UNITED STATES PATENT AND TRADEMARK OFFICE

APPLICATION NO.	FILING DATE	FIRST NAMED INVENTOR	ATTORNEY DOCKET NO.	CONFIRMATION NO.
10/532,430	04/25/2005	Kenji Yamane	OGW-0365	1792

Office Action Summary	Application No.	Applicant(s)	
	10/532,430	YAMANE, KENJI	
	Examiner	Art Unit	
	Steven D. Maki	1791

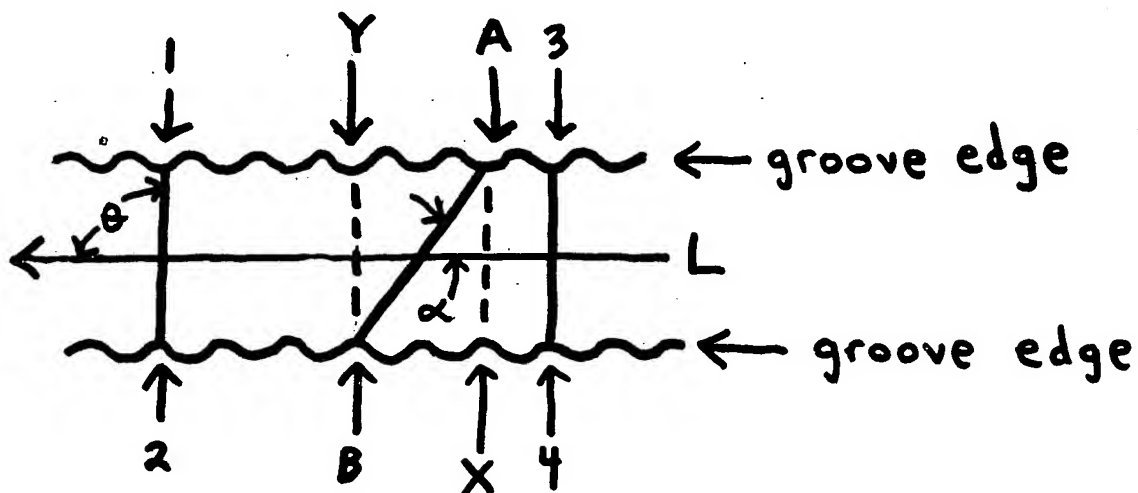
Heinen teaches providing the peaks and valleys on a first side such that they 180 degrees out of phase from the peaks and valleys on the second side surface. Attention is directed to the following figure:

The undulating lines in the above figure represent the edges of a groove at the tread surface. The peaks and valleys at one groove edge are 180 degrees out of phase from the peaks and valleys at the other groove edge. For example, peak 1 is directly opposite peak 2. Another example, peak 3 is directly across from peak 4. A continuous peak can extend from peak 1 to peak 2 along a line inclined at angle θ with respect to the line L (the longitudinal direction of the groove) wherein angle θ is 90 degrees. However, a continuous peak can extend from peak A to peak B along a line inclined at angle α with respect to line L (the longitudinal direction of the groove). This is true even though peak A is directly across from peak X and peak B is directly across from peak Y. The path of a continuous peak from one groove edge to the other groove edge is independent of the phase of the peaks at the tread surface. More importantly, Heinen fails to require peaks and valleys on one side surface to be 180 degrees out of phase from the peaks on the other side surface. In Heinen, the longitudinal direction of groove corresponds to the imaginary line or arc located on the median plane within the depth of the groove wherein the median plane bisects the channel formed by the respective surfaces of the groove. See col. 5 lines 59-67. Heinen teaches that the peaks and valleys follow imaginary lines that are skewed with respect to the median plane line or arc at 45 to 90 degrees. See col. 6 lines 1-4. Heinen teaches that the lines are skewed at 90 degrees in the preferred embodiment, which is illustrated in figure 7. See col. 4 lines 28-29, col. 6 lines 4-7. With respect to this skewing at an angle of 45-90 degrees, Heinen explains:

This angle measured by transposing each line or arc into the same plane and measuring the angle at the intersection of the respective lines.

See col. 6 lines 7-9 (emphasis added). When applicant created figure 3 of the original disclosure, applicant transposed the line followed by the ridges or peaks 4 into the same plane (the tread surface) in order to measure angle alpha. Heinen's angle of 45-90 degrees at which the peaks and valleys may be skewed directly corresponds to the angle alpha indicated in figure 3. Thus, Heinen discloses an angle of 45 to 90 degrees. Heinen does not recite an angle of "10 degrees to less than 45 degrees".
